Supplementary Report

Rum Jungle Rehabilitation Project – Environmental Impact Statement

| Date Issued | 18/06/2020 |

Figure 3-18 Map of the zoning applied in Hydrobiology reports for the Finniss River and locations of key monitoring sites used for the development of LDWQOs.

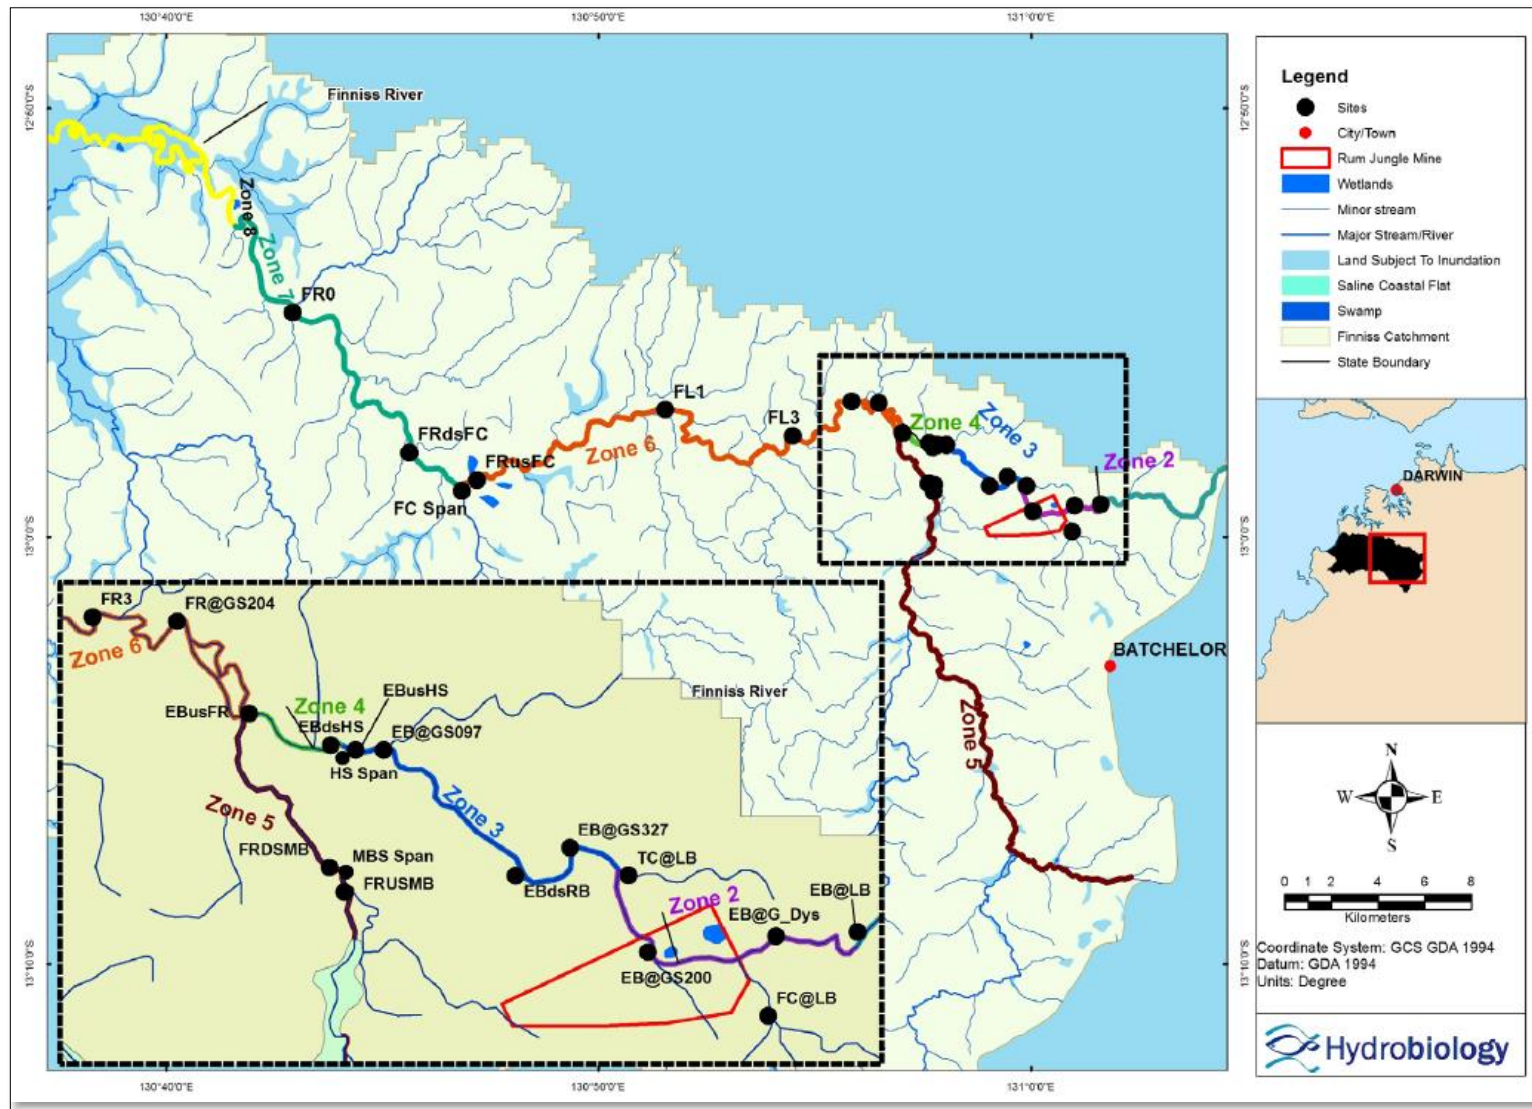
| 25 | NT EPA | Environmental values/beneficial uses | 10.2.1 Environmental Values 11.1 Environmental Values 12.1 Environmental Values | <p>The Draft EIS and appendices refer to Hydrobiology 2013a and Hydrobiology 2016 for details on Environmental values. The former document (Phase 1 of the 2013 report) was not provided in the appendix.</p> <p>No reference is made to Beneficial Uses listed in or declared for the area under the NT Water Act 1992.</p> <p>Provide:</p> <ul style="list-style-type: none"> • A copy of Hydrobiology 2013a – Environmental Values Downstream of the Former Rum Jungle Mine site –Phase 1 • An updated summary of Environmental Values/Beneficial Uses for surface and groundwater, similar to Table 6-1 in Hydrobiology 2013a, plus with consideration of Beneficial Uses listed in or declared under the Water Act 1992. • An analysis of whether the updated LDWQOs (Hydrobiology 2016) are still sufficiently stringent to protect all identified Environmental Values/Beneficial Uses, equivalent to the analysis provided in Tables 6-2 to 6-18 in Hydrobiology 2013a. | <p>See Section 3.9 EBFR Beneficial Uses.</p> <p>The requested report (Hydrobiology 2013a) is provided in Appendix 3.</p> |

The Northern Territory *Water Act* (1992) lists nine beneficial use categories. The Finniss River catchment is part of the Fog Bay area. The declared beneficial uses for Fog Bay area (as per Government Gazette No. G9 and G20 (1998a, 1998b)) are aquatic ecosystem protection and recreation water quality aesthetics (Figure 3-18), therefore corresponding to only two of the beneficial use categories listed under the *Water Act*.

Figure 3-24 Construction Phase Water Treatment and Management

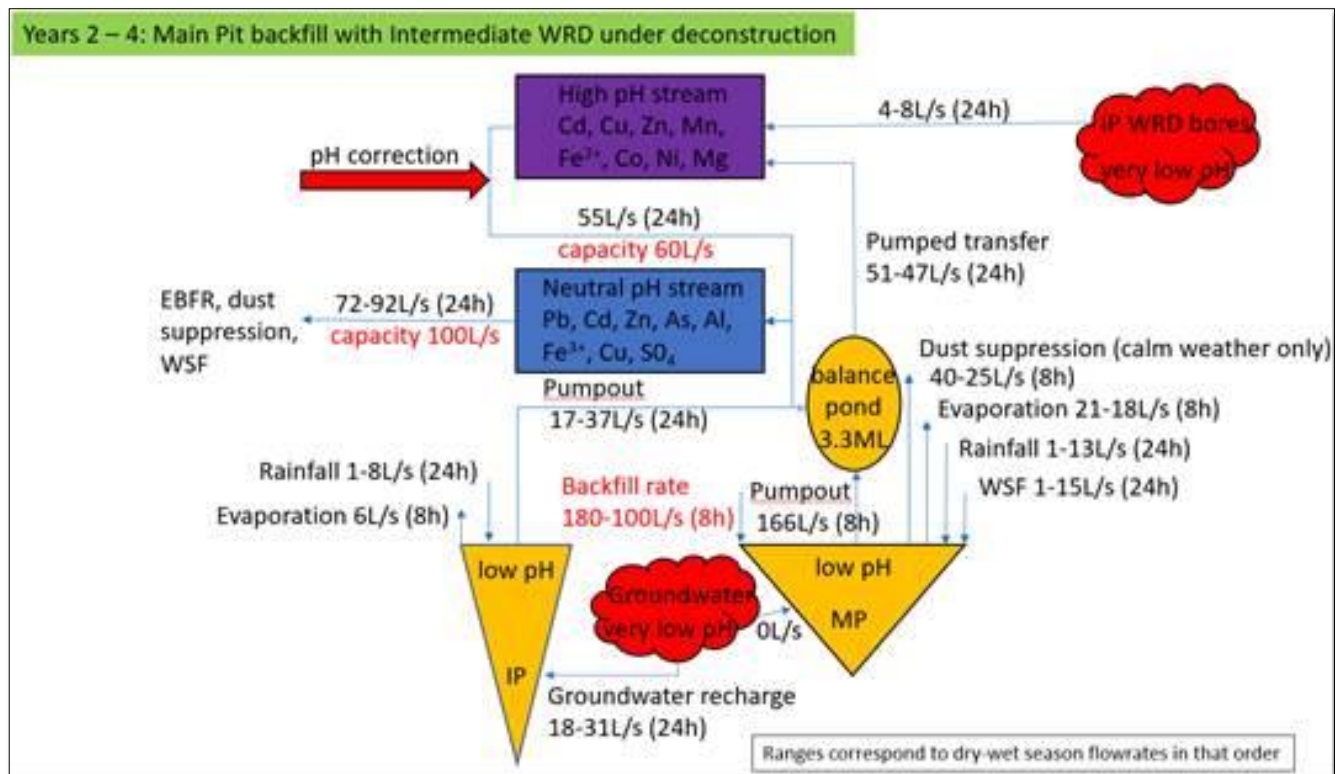
| 24 | NT EPA | WTP discharge location | 7.10.1 Water Treatment DPIR 2019 – 4.1.15.3 Inferred EBFR Water Quality during Stage 3 | <p>The proposed WTP discharge location in the Draft EIS (Figure 7-12) is at the end of the East Finniss diversion channel (EFDC), while the discharge location in the Water Management Plan (WMP) (DPIR 2019, section 4.1.15.3) is near the beginning of the EFDC.</p> <p>Clarify the proposed WTP discharge location.</p> | It is proposed that the WTP discharge during the operational period will be upstream of Gauge Station 8150200 (as per Figure 7-12 Draft EIS). It is acknowledged though that this should be with the agreement Browns Oxide mine to ensure that there are no adverse impacts to their pit. After the cessation of pit backfilling it is proposed to consider discharging the WTP-treated water to the upstream side of the Main Pit should it prove advantageous in accelerating establishment of aquatic and riparian vegetation and in accelerating stabilisation of erosion/sedimentation structures (WMP section 4.1.15.3). |

The following image has been extracted from Appendix 19 (SLR 2020j WTP Design Report) and demonstrates the requirements of the site water treatment and management regime during construction. It demonstrates the flexibility required in the design and the reason for the potential variability of discharge to the EBFR. The values given in this simplistic schematic are the likely operating flow rates.

Dry season WTP discharge has been refined and is likely to average 15L/s; however, this may range from 10-100L/s at any time. This accumulates for a total dry season discharge of approximately 9ML/week or 0.2GL total for the dry season (as shown in section 11.2.1 of the draft EIS). The impact of the proposed WTP discharge regime is described in the Draft EIS Section 11.2.1. These flow rates are likely to increase during the Stabilisation Phase as there will be no demand for construction water. As shown above, the estimated Stabilisation Phase dry season discharge is 10 ML/week or 0.3 GL/dry season.

Figure 3-25 Comparison of Simulated and Observed Heads and Calibration Results

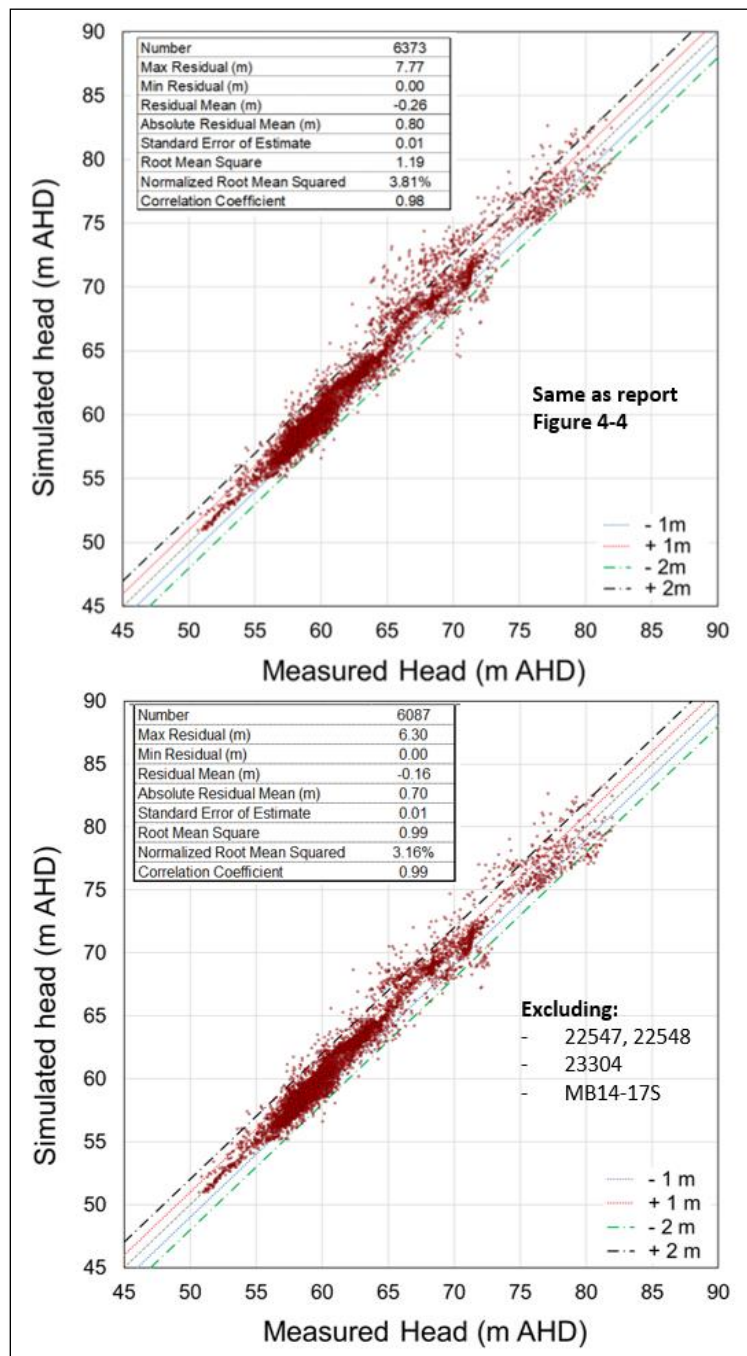
| | | | <p>plume. The lithology map indicates this may put the plume in different geological formations.</p> <p>A bimodal pattern is noted in the calibration results of simulated versus observed heads (Figure 4-4). Below approximately 65 m AHD nearly all the results fit between +2 m variation. However, above 65 m the spread of data becomes much wider with many points showing a difference greater than +5 m. Given the majority of the data is for groundwater elevations below 65 m AHD this may be biasing the calibration statistics.</p> <p><u>Sensitivity and uncertainty analysis</u></p> <p>The Draft EIS provides a comparison between observed and modelled loads in the EBFR of Cu and SO₄. Observed and simulated loads differ up to 43% for SO₄ and up to 60% for Cu in a given water year. The results are considered a “reasonable” agreement by the author of the report, however the term “reasonable” is not defined further.</p> <p>The report states that the ranges of flow and transport parameters used in the sensitivity analysis are considered “plausible”, however, a clear explanation of how ranges were derived is not given.</p> <p>Additional uncertainty analysis is recommended (e.g. as described in Middlemis and Peeters 2019).</p> <p>The report contains 14 recommendations to reduce model uncertainties but no indication was given in the Draft EIS if these will be implemented.</p> <p><u>Model Assumptions</u></p> <p>Provide justification for the use of the selected single dispersivity values to represent dispersivity for heterogeneous geological formations.</p> <p><u>Differences between observed and modelled current conditions</u></p> <p>Provide clarification of differences between observed and modelled current conditions, including:</p> <ul style="list-style-type: none"> • an explanation for the discrepancy in plume locations and whether this may have implications for the predicted contaminant transport. • an explanation of the bimodality in the calibration data as well as separate calibration statistics above and below 65 m AHD. <p><u>Sensitivity and uncertainty analysis</u></p> <p>Provide</p> <ul style="list-style-type: none"> • an explanation for the choice of parameter ranges used in sensitivity analyses | |

With respect to the bimodal distribution in water levels, most of the spread in water levels on the scatter plot (above 65 m AHD and greater than 2 m) is caused by local discrepancies between bores RN022547 and RN022548 (which are 15 m apart) and bores RN023304 and MB14-17S. Figure 3-25 compares simulated and observed heads with these bores included and excluding these bores, as requested. Calibration statistics showed a significant improvement (NRMSE dropped from 3.8 to 3.2) if the bores mentioned above are excluded.

Figure 3-25 below shows (top) all monitoring wells included in the data which is the same as Figure4-4 from Robertson GeoConsultants (2019) report provided with the Draft EIS. The bottom figure is for all wells with RN022547, RN22548, RN23304 and MB14-17S excluded.
